REMARKS

Objection To The Drawings:

FIG. 1

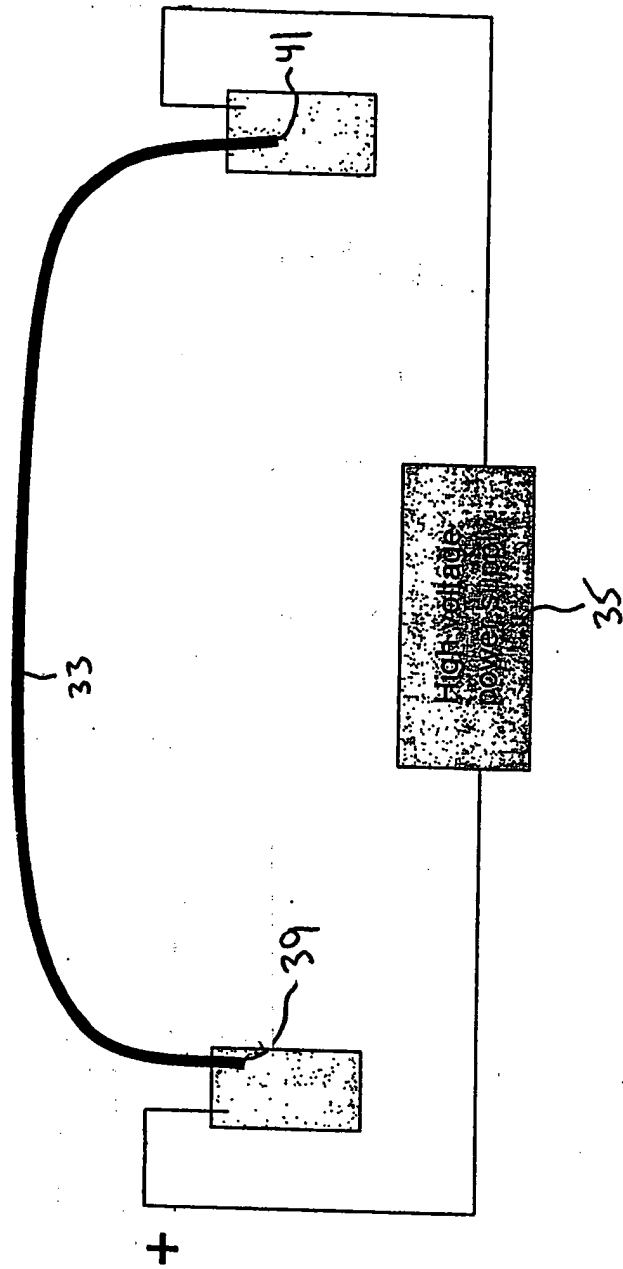
The August 5, 2004 Office Action objected to FIGS. 1 and 2, stating:

Figures 1 and 2 should be designated by a legend such as --Prior Art--because only that which is old is illustrated. See MPEP § 608.02(g). Corrected drawing sheets are required in reply to the Office action to avoid abandonment of the application. The replacement sheet(s) should be labeled "Replacement Sheet" in the page header (as per 37 CFR 1.84(c)) so as not to obstruct any portion of the drawing figures. If the changes are not accepted by the examiner, the applicant will be notified and informed of any required corrective action in the next Office action. The objection to the drawings will not be held in abeyance. (August 5, 2004 Office Action; Page 2).

With this Response, FIGS. 1 and 2 have been amended to include the legend "Prior Art." Please find enclosed: Replacement Sheet displaying FIG. 1, Replacement Sheet displaying FIG. 2, a sheet illustrating the changes made to originally filed FIG. 1 (changes shown in red), a sheet illustrating the changes made to originally filed FIG. 2 (changes shown in red), and Applicant has resubmitted original FIGS. 3-7 (for completeness). As such, Applicant respectfully requests that the objection to the drawings be withdrawn.

Prior Art
